**SOLICITATION AMENDMENT
MODIFICATION DE L'INVITATION**

Title - Sujet Wood Islands Ferry Terminal Infrast Wood Islands Ferry Terminal Infrastructure Rehabilitation – Phase 3 Wood Islands	
Solicitation No. - N° de l'invitation ED001-211613/A	Amendment No. - N° modif. 008
Client Reference No. - N° de référence du client ED001-211613	Date 2020-12-30
GETS Reference No. - N° de référence de SEAG PW-SPWC-008-4534	
File No. - N° de dossier PWC-0-43027 (008)	CCC No./N° CCC - FMS No./N° VME
Solicitation Closes - L'invitation prend fin at - à 02:00 PM Atlantic Standard Time AST on - le 2021-01-07 Heure Normale de l'Atlantique HNA	
F.O.B. - F.A.B. Plant-Usine: <input type="checkbox"/> Destination: <input checked="" type="checkbox"/> Other-Autre: <input type="checkbox"/>	
Address Enquiries to: - Adresser toutes questions à: Reay, D (PWC)	Buyer Id - Id de l'acheteur pwc008
Telephone No. - N° de téléphone (902) 314-7957 ()	FAX No. - N° de FAX (902) 566-7514
Destination - of Goods, Services, and Construction: Destination - des biens, services et construction:

Le présent addenda vise à présenter les réponses suivantes aux questions posées par les soumissionnaires.

APPENDICE 1 - FORMULAIRE DE PRIX COMBINÉS--- Révisé le 30 décembre 2020

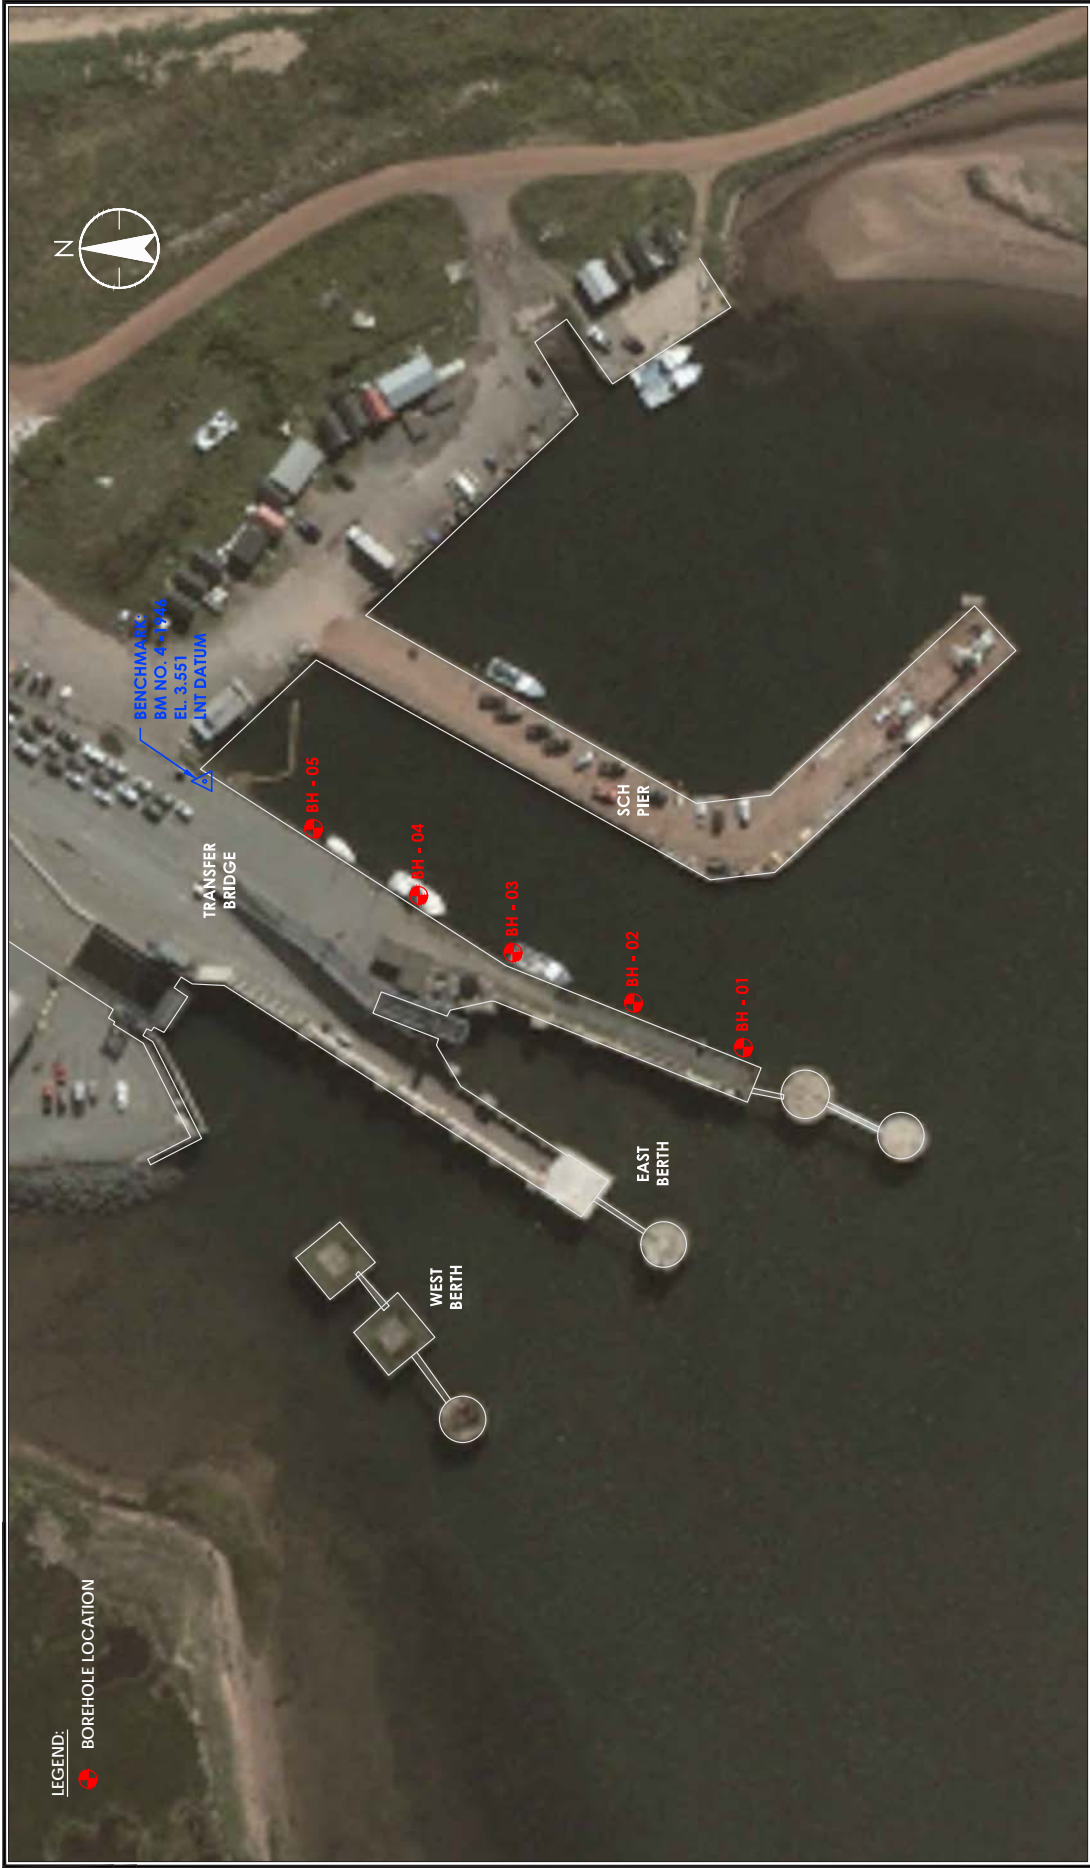
Q10

Please confirm the bid sheet ladder stand off quantity is correct (one listed on the bid form).

A10

Revised the bid sheet quantity from 1 to 3.

See attached APPENDIX 1 - COMBINED PRICE FORM ----REVISED DECEMBER 30, 2020.

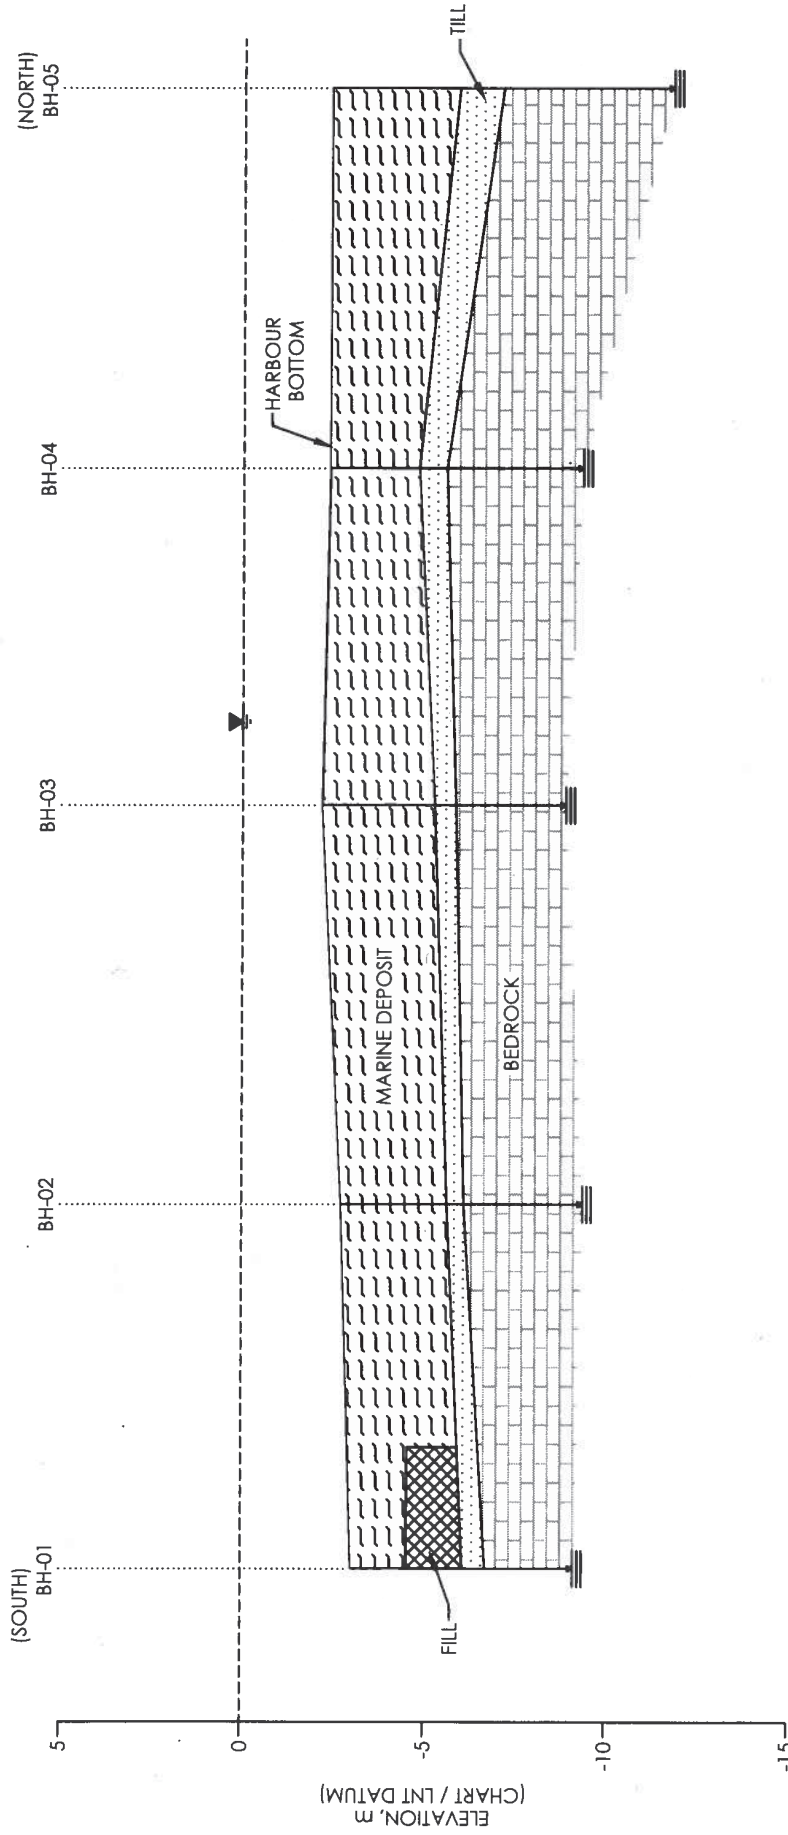
Q12

At this time we are seeking clarifications/information on the existing soil conditions at the project site. Are you able to provide borehole logs, or any other information regarding the existing soil conditions at the site?

A12

See attached Borehole Logs
